Staff Summary Report

SUBJECT: Hold a public meeting for a Development Plan Review for RYAN'S EXPRESS TRANSPORTATION SHOP & OFFICE located at 820 North McClintock Drive.

DPR07249 – Development Plan Review including site plan, building elevations, and landscape plan.

DPR07249 CONDITIONS

GROUND FLOOR PLAN
SCALE: 1/8" = 1'-0"

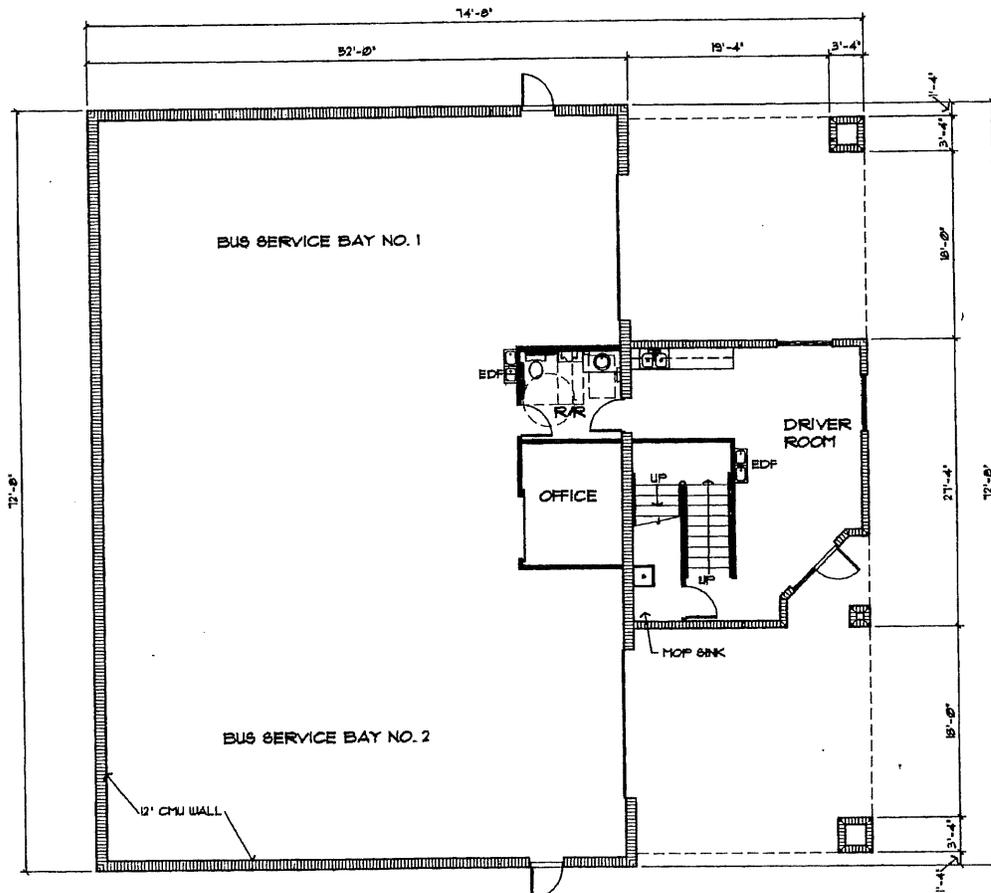
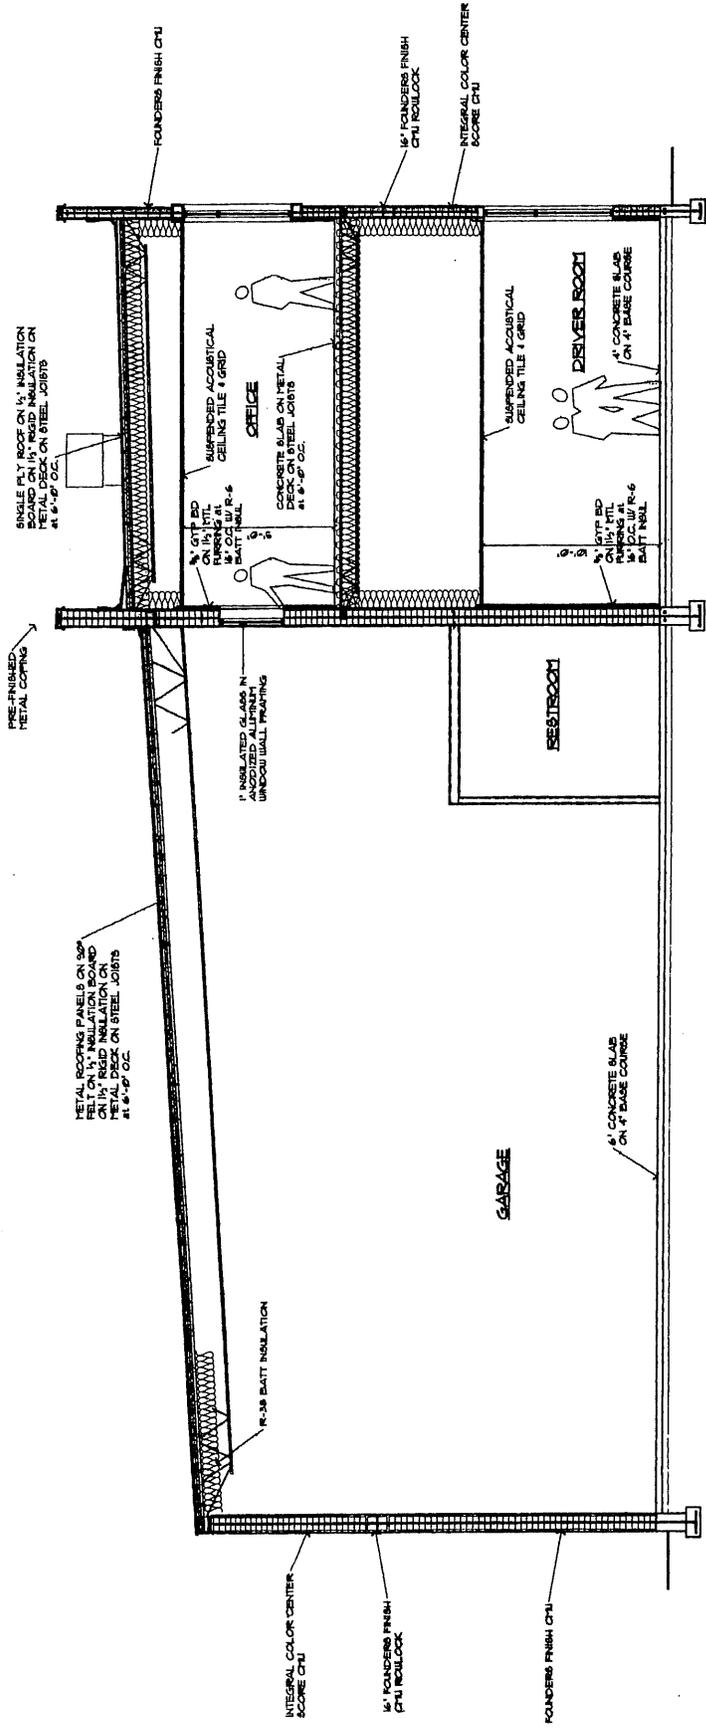
5. Restroom Security in maintenance shop building and one-story office building:
 - a. Lights in restrooms:
 - 1) Provide 50% night lights
 - 2) Activate by key or remote control mechanism
 - b. Single user restroom door hardware: Provide a key bypass on the exterior side.

SOUTH ELEVATION
SCALE: 1/8" = 1'-0"

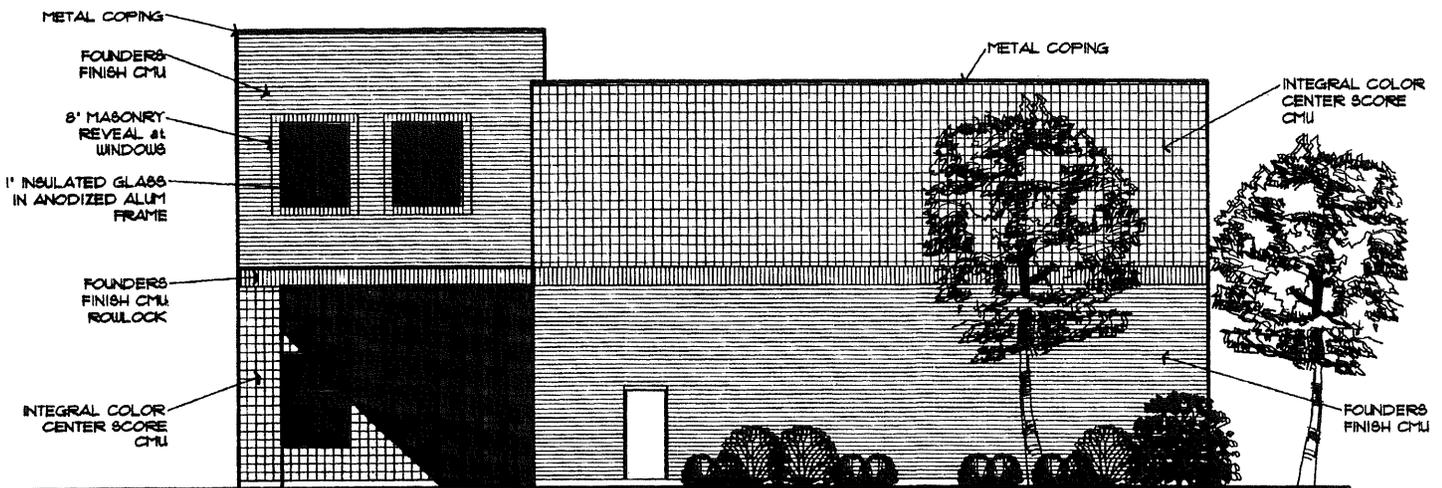
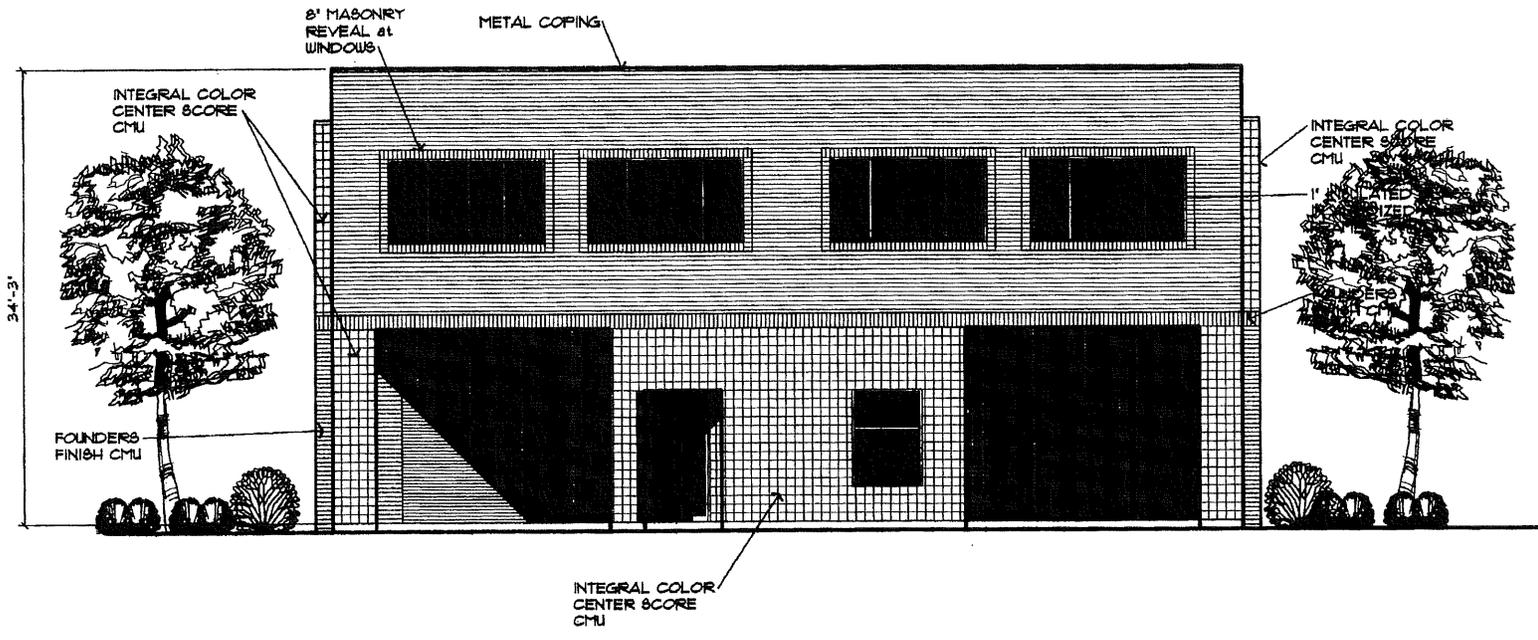
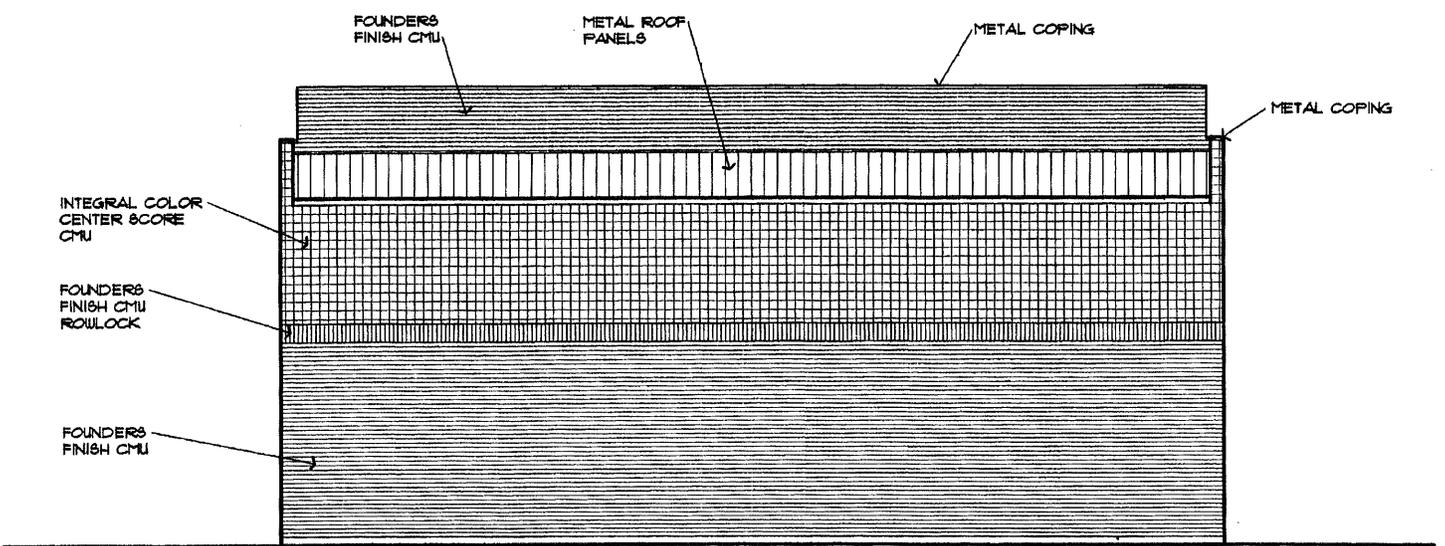
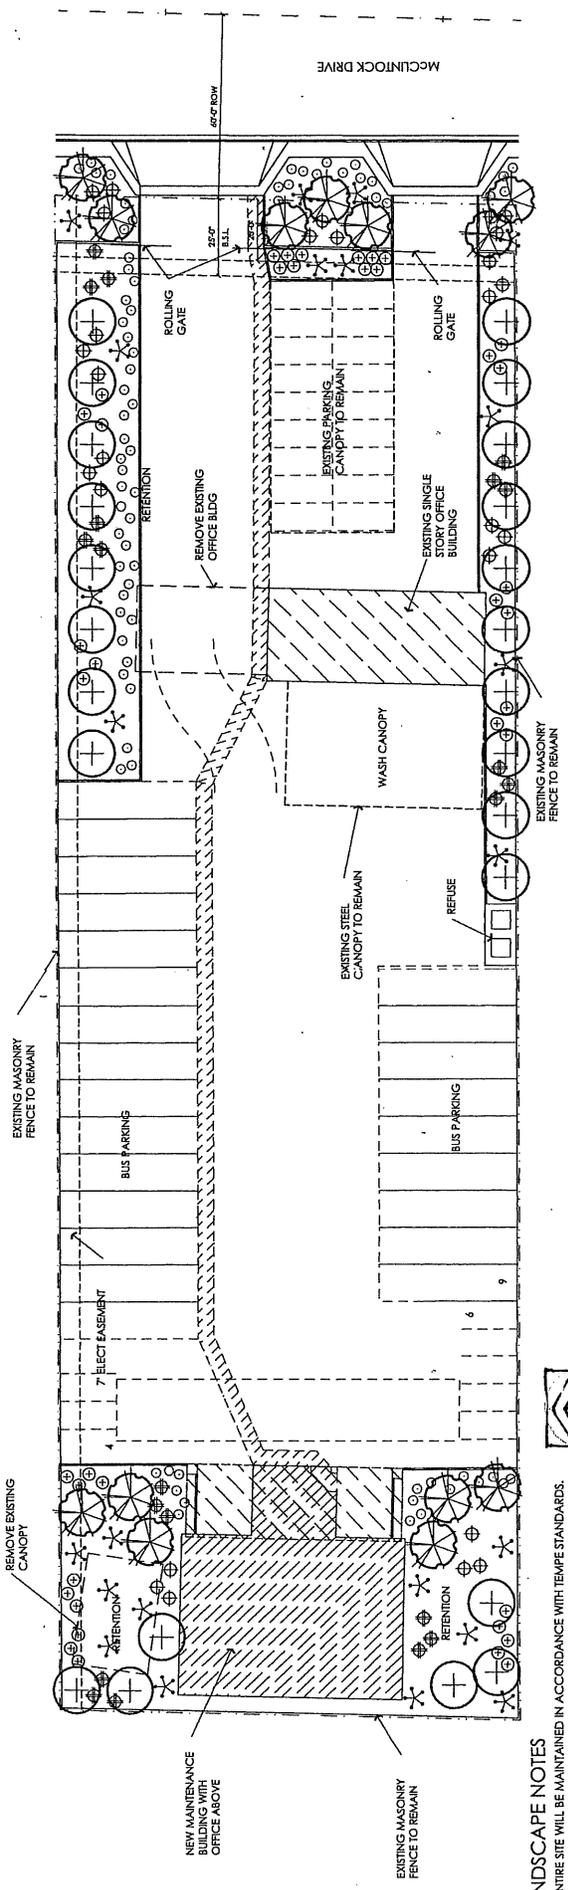
6. The materials and colors included in the submittal (Masonry 1: Founder Finish CMU - Autumn Blend, Masonry 2: Center Score plain gray CMU, Metal Roof: Ceram-a-Star 950 Polar White, and Metal Doors and Frames: Dunn Edwards DE6279 – Armored Steel) are part of the approval. Re-paint existing site canopy fascias and existing one-story building doors Armored Steel (green) to match the color proposed for the steel doors of the maintenance shop building.

7. Add frame & exterior plaster parapet to one-story building all around sufficient to fully conceal roof mount mechanical equipment. Paint exterior plaster parapet a color that compliments the beige color of the exposed slump block of the one-story office building. Match the exterior plaster color of the parapet to the color proposed for the perimeter masonry wall. Do not paint slump block on one story building.

9. Conceal roof drainage system for the two-story portion of the maintenance shop within the interior of the building. Minimize visible, external features, such as overflows, and position these where needed to enhance the architecture. The existing exposed roof drainage system for the one-story building may remain. Incorporate any modifications to this roof drainage system with the parapet addition.

10. Incorporate lighting, address signs, incidental equipment attachments (alarm klaxons, security cameras, etc.) for both buildings into the design of the building elevations. Do not expose conduit, piping or ductwork on the surface of the buildings unless a creative conduit surface design that compliments the architecture is separately reviewed and approved by the Development Review Commission.

11. Provide secure maintenance shop roof access from the interior of the building to the roof above the second floor. Do not expose roof access to public view.
